UNITED STATES PATENT AND TRADEMARK OFFICE

APPLICATION NO.	FILING DATE	FIRST NAMED INVENTOR	ATTORNEY DOCKET NO.	CONFIRMATION NO.
10/803,769	03/18/2004	Steven J. King		6698

Office Action Summary

DETAILED ACTION

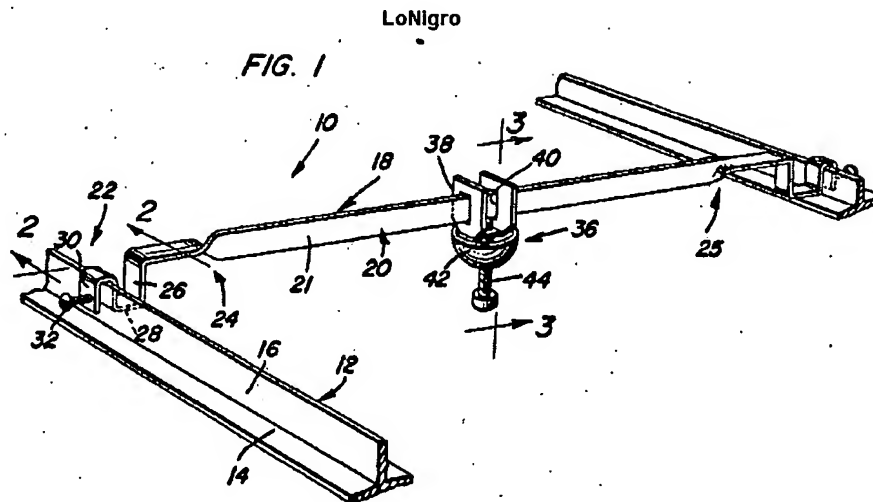
1. Claim 8 is objected to because of the following informalities: When read it appears that both a first and a second portion are one unit that is then coupled to another first portion, as a result this language leads to ambiguity. Clarification of the language is desired. Preferred language may read as follows: "the elongated support includes a first portion, and a second portion the second portion being coupled to the first portion for selectively adjusting a length of the elongated support." Appropriate correction is required.
2. Claim 25 is objected to because of the following informalities: Claim 25 appears to have a grammatical error between the words "portion" and "is." When read claim 25 appears to be missing a word or words that would allow the claim to be better understood. Appropriate correction is required.

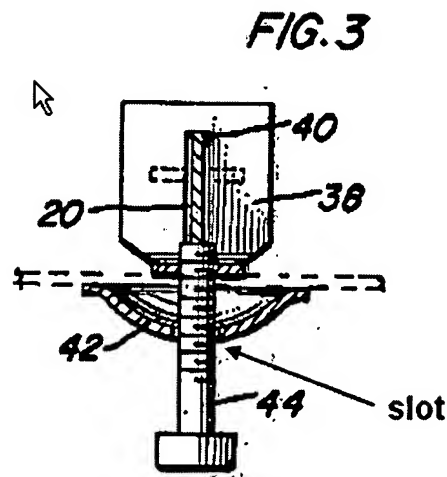
5. In Re claim 4, Figure 3 of LoNigro discloses a collar (38) slidably mounted on the elongated support (18) for positioning the tile support at a desired location thereon, the collar (38) defining a slot (see figure below); and a spacer bar (44) passing through the slot such that a lower end of the spacer bar (44) can support a ceiling tile.

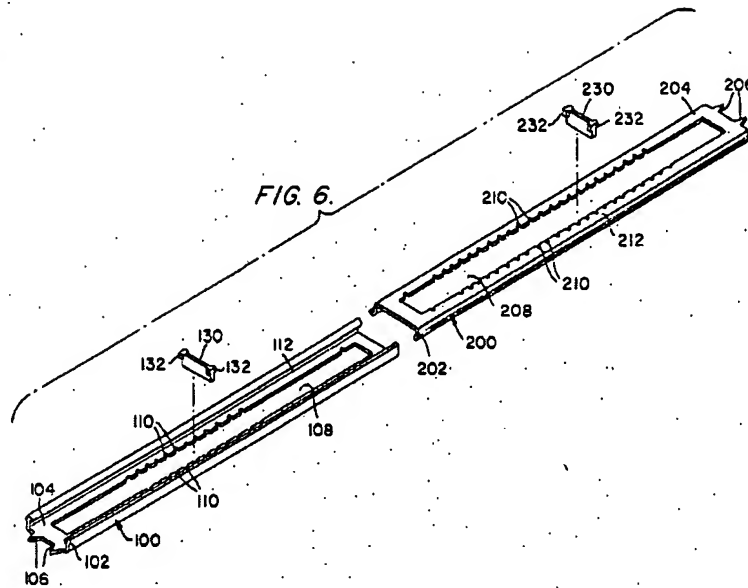
7. **Claim 29 rejected under 35 U.S.C. 102(b) as being anticipate by Fredman (US 5,203,039).** Figure 1 and Column 2 Lines 48-52 of Fredman disclose an elongated support (10) having a variable length (13 and 14 are separate sections of 10, allowing it to vary in length), each end of the elongated support (10) having first means for engaging (31 of 10); and a pair of vertical supports (30), with second means for engaging (31 of 30) the first means (31 of 10) such that the pair of vertical supports (30) can be rotated parallel to the elongated support for compact packaging of the preassembled hanger assembly. Examiner notes the language; "each support having

a lower portion for coupling to the ceiling and an upper portion" is an intended use recitation. Since Fredman is capable of performing the intended use, it is considered to meet the claim.
